# STAFF REPORT ACTION REQUIRED

## 1-17 Anndale Drive, 31-35 Bales Avenue and 22-70 Glendora Avenue – Rezoning and Site Plan Control Applications - Request for Direction Report

<b>Date:</b>	August 18, 2008
<b>To:</b>	North York Community Council
<b>From:</b>	Director, Community Planning, North York District
<b>Wards:</b>	Ward 23 – Willowdale
<b>Reference Number:</b>	07 230632 NNY 23 OZ & 08 144682 NNY 23 SA

# Attachment 1: Site Plan

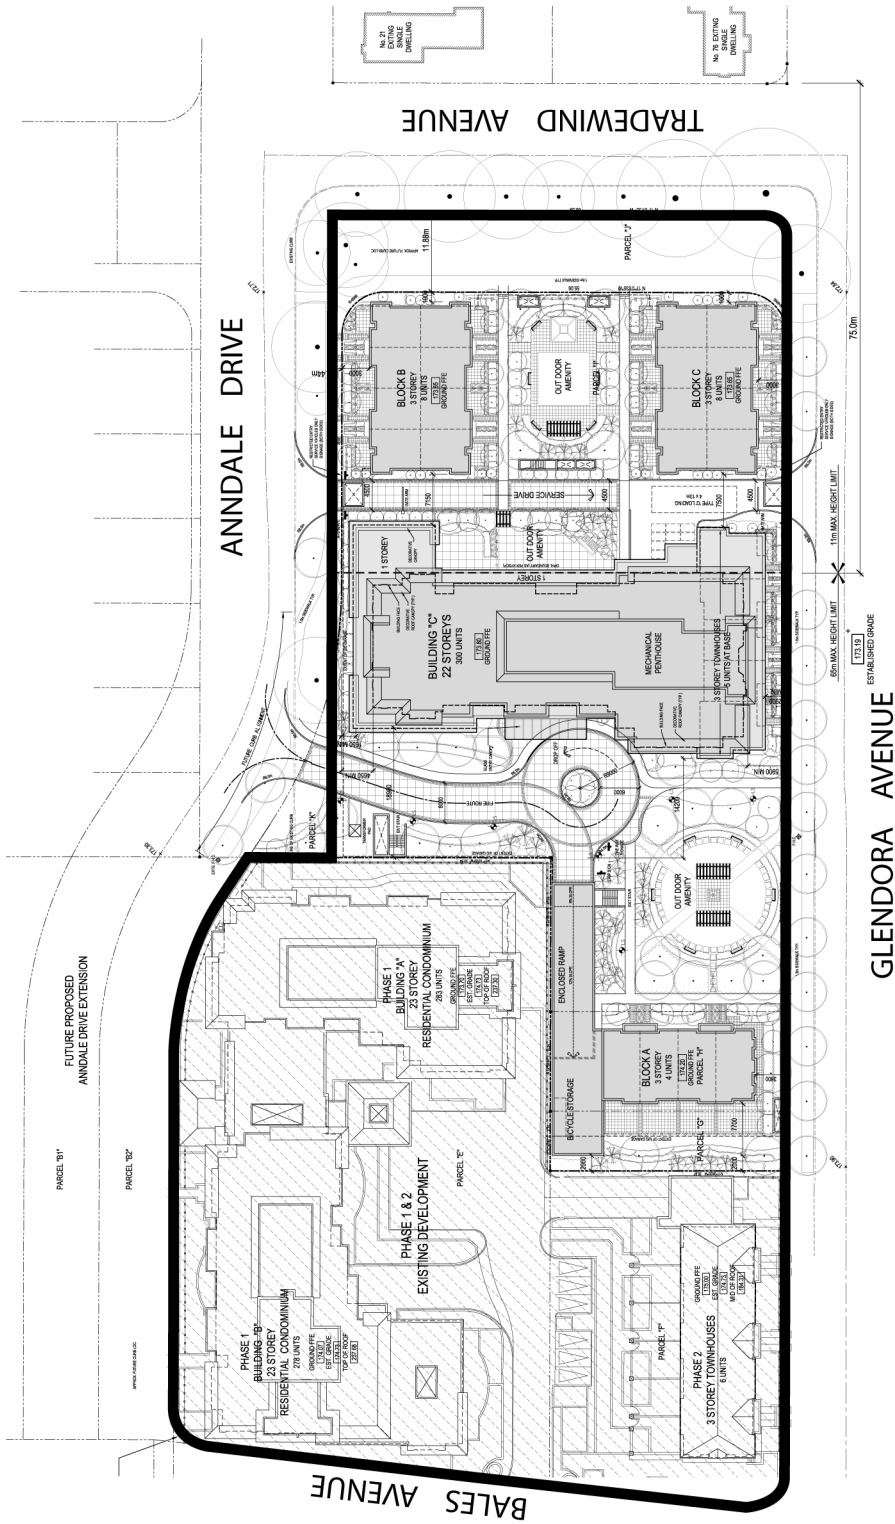
- 14.1 The following changes are required to the Site Plan Drawing A1-2, dated June 21, 2008 by Rafael+Bigauskas Architects:
  - a) Clearly label new property line location along Anndale Drive and Tradewind Avenue.

- b) Revise the site plan to show that all access driveways will be constructed in accordance with City of Toronto Engineering Design Standard T-350.01.

- c) The site plan fails to address the following items with respect to Fire Access Route requirements of the Ontario Building Code:
    - Load support shall be sufficient to support the expected loads imposed by fire fighting equipment & shall be surfaced in order to be accessible under all climatic conditions.
